April 3, 2024

IDEA Public Schools Upper RGV Mechanical Upgrades CSP#23-URMU-0424

ADDENDUM NO. 2

IDEA QUEST BUILDING F MECHANICAL & ELECTRICAL FLOOR PLAN
SCALE: 1/8" = 1'-0"

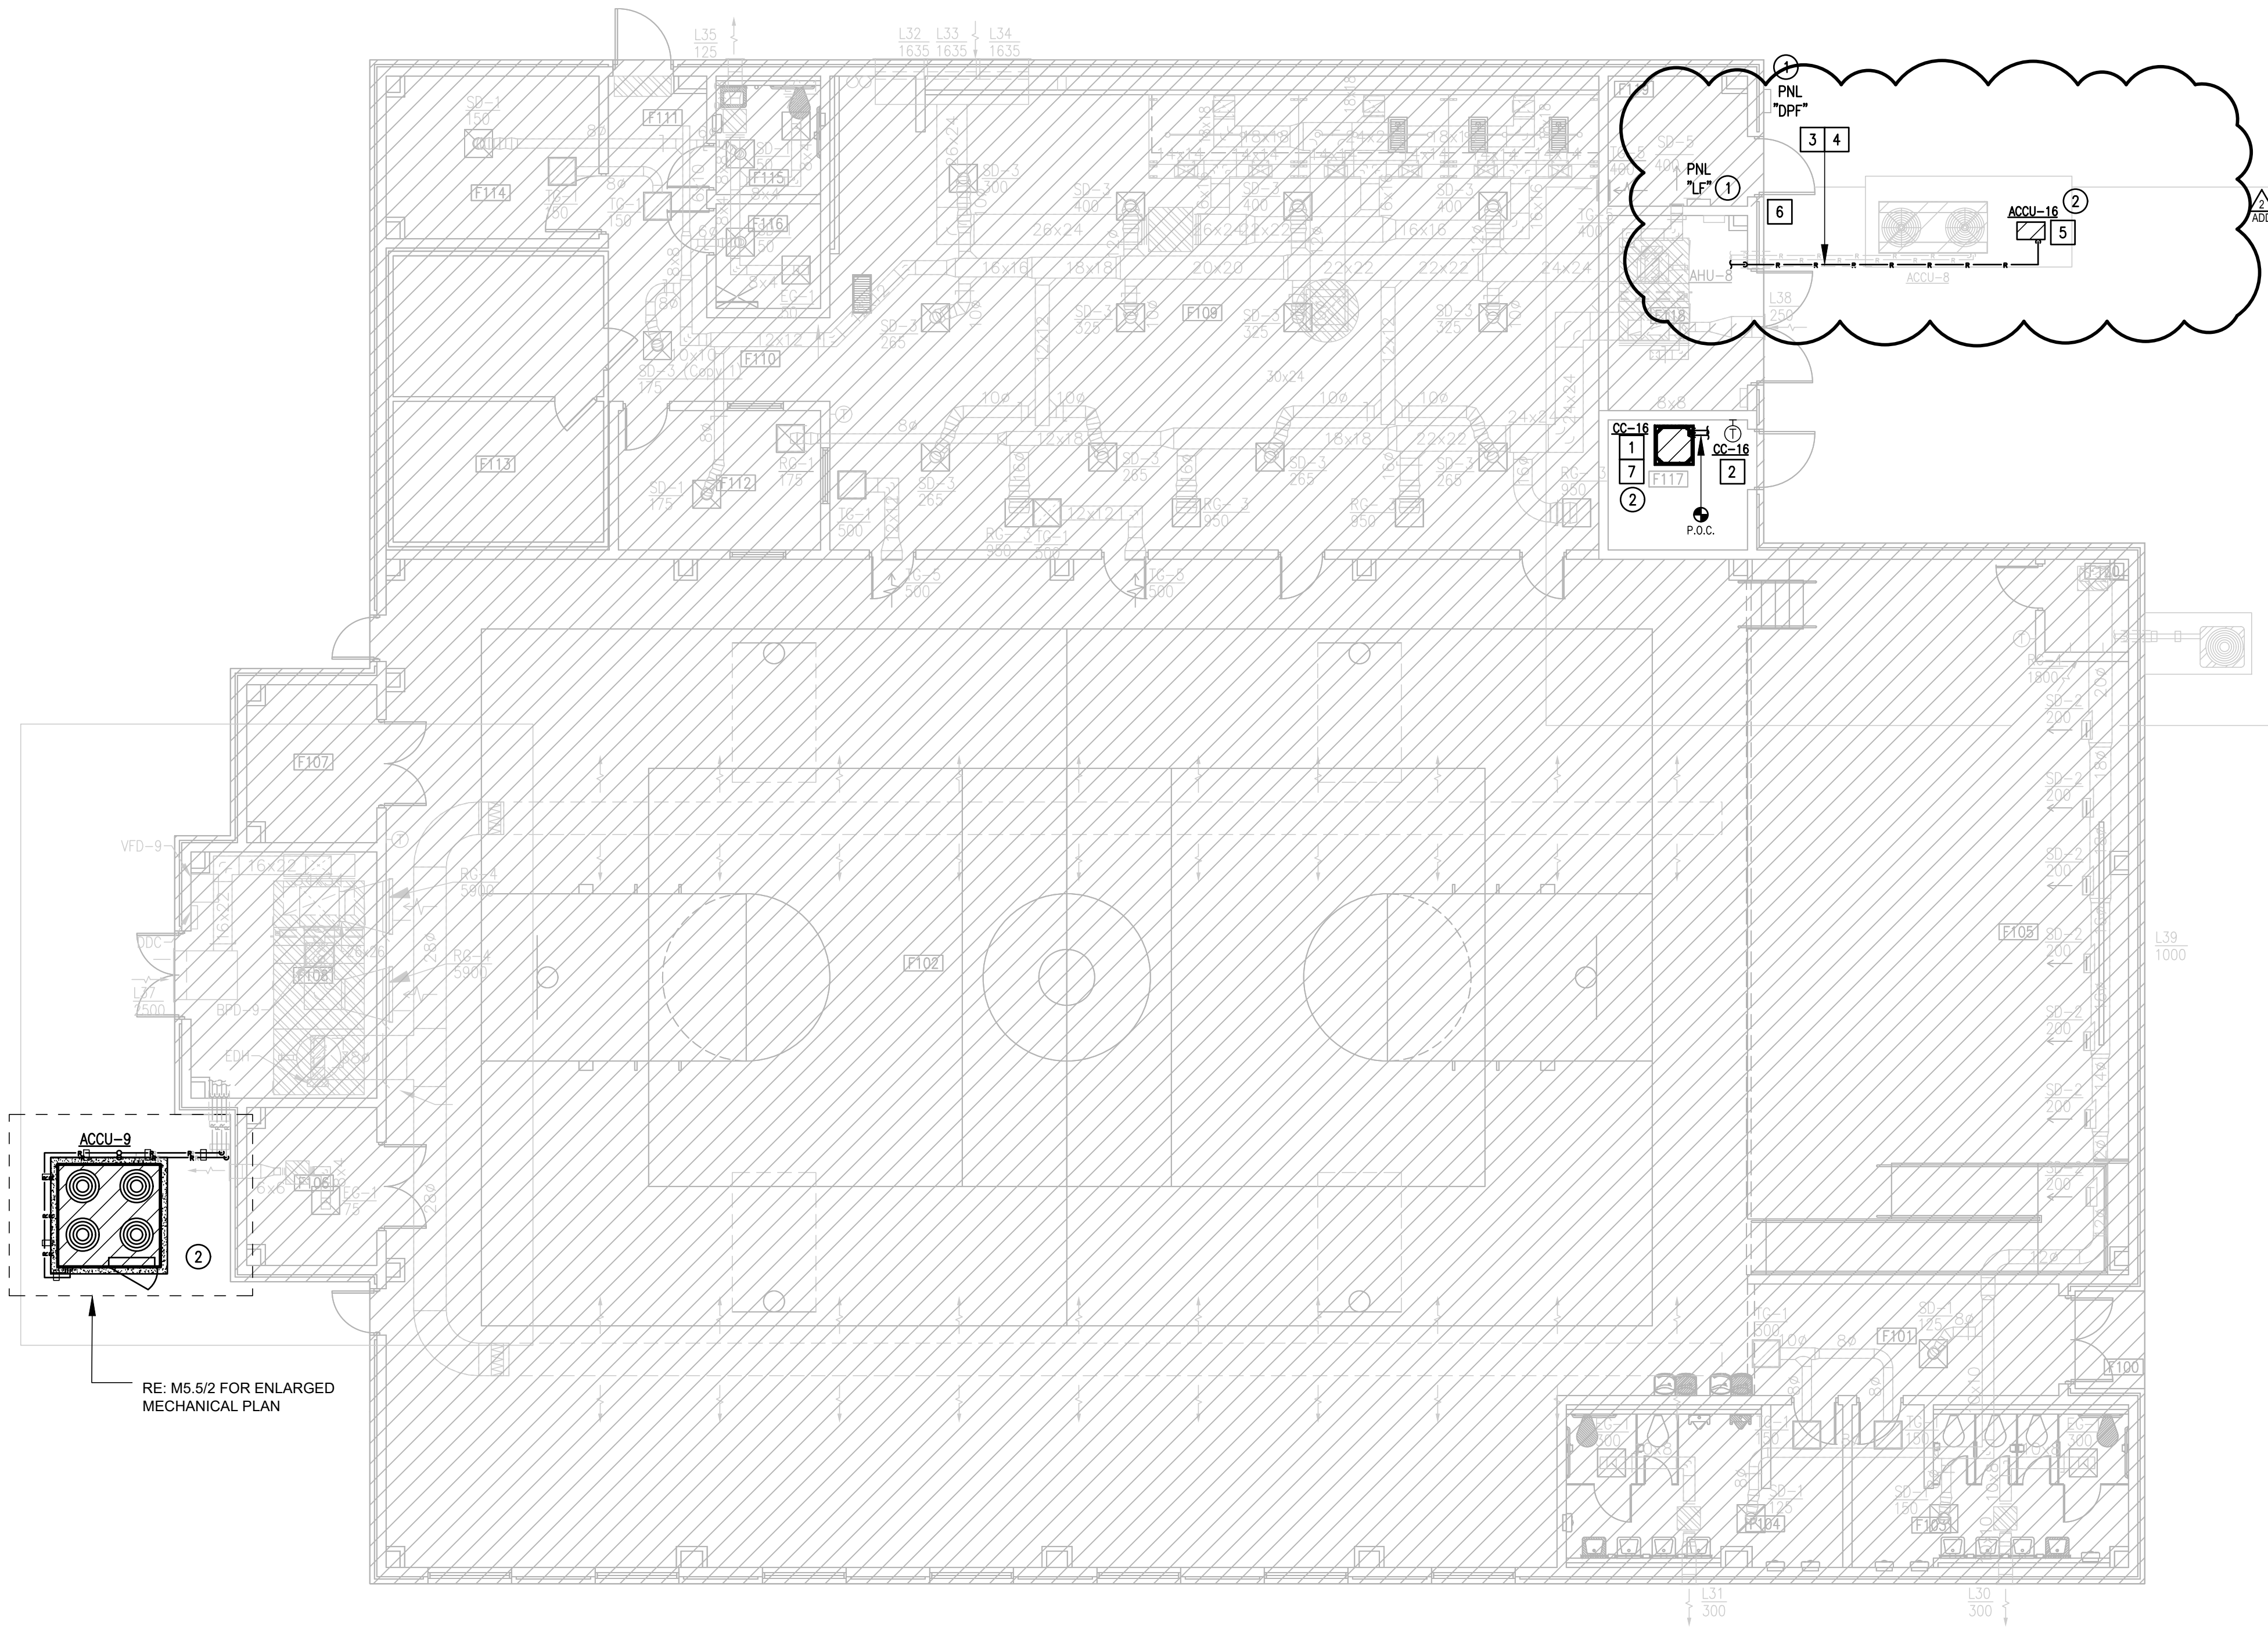
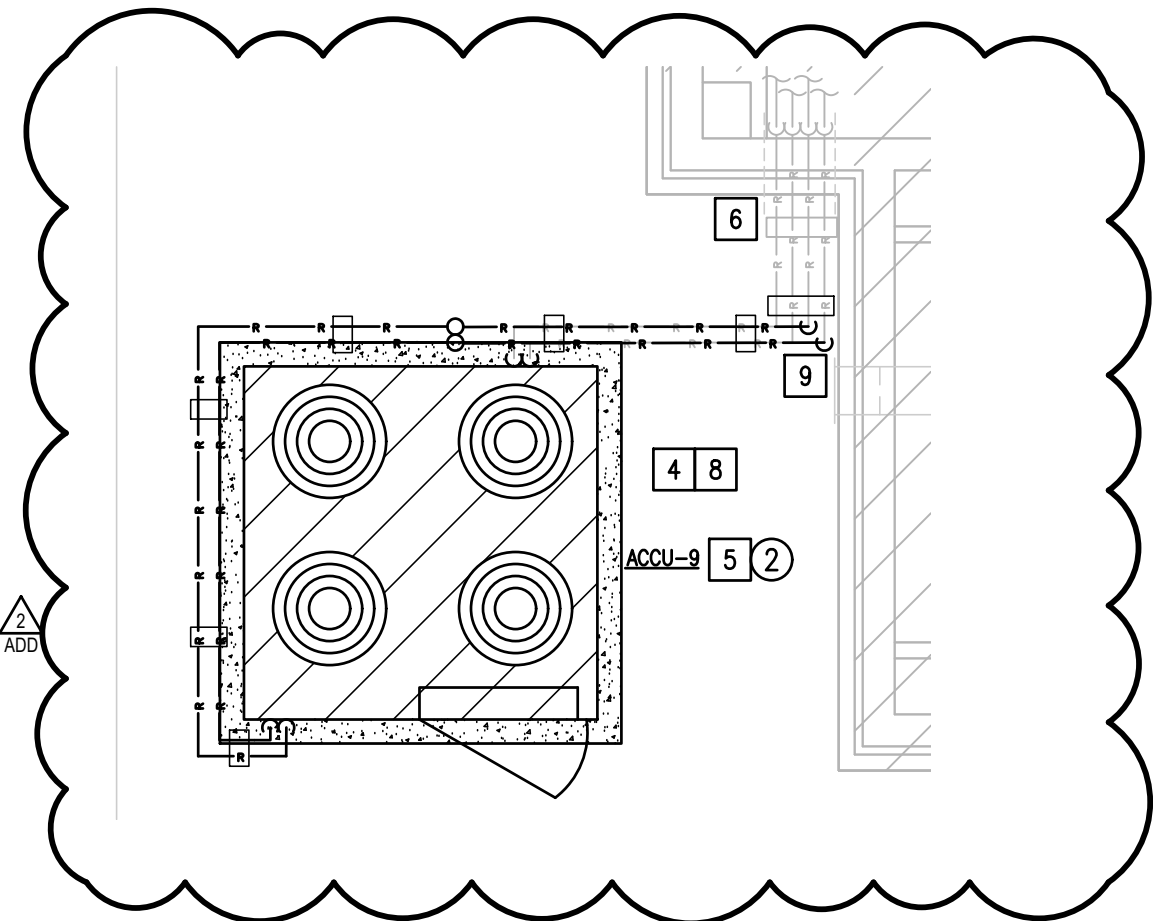
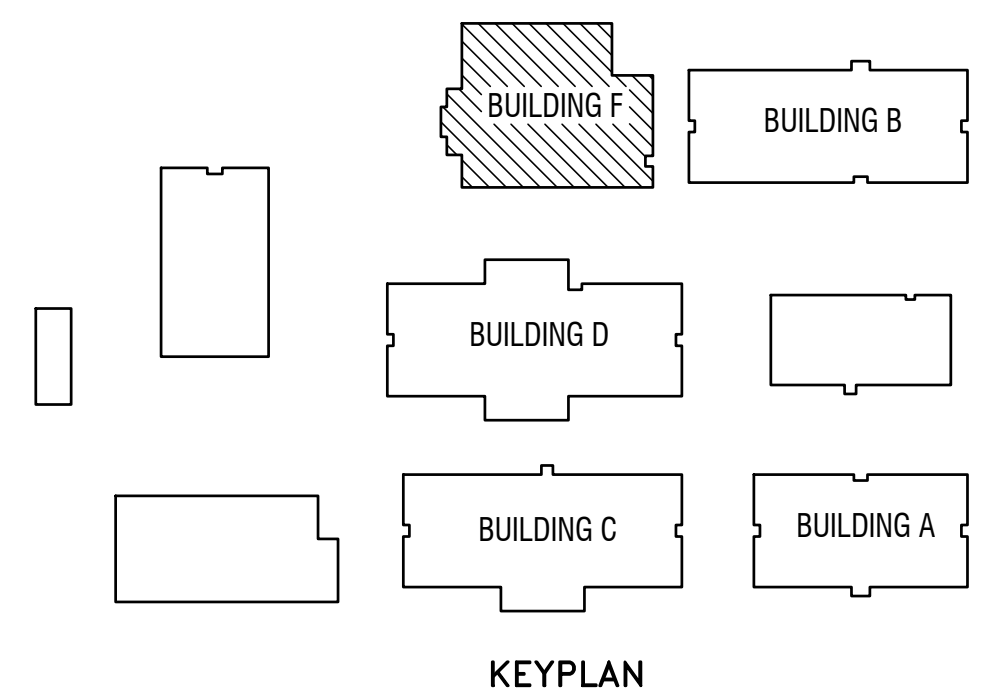
13. Sheet ME-5.5 – See attached.
 - a) Added Base Bid identification to schedules.
 - b) Updated mini-split ACCU location.
 - c) Calling for new housekeeping concrete pad.
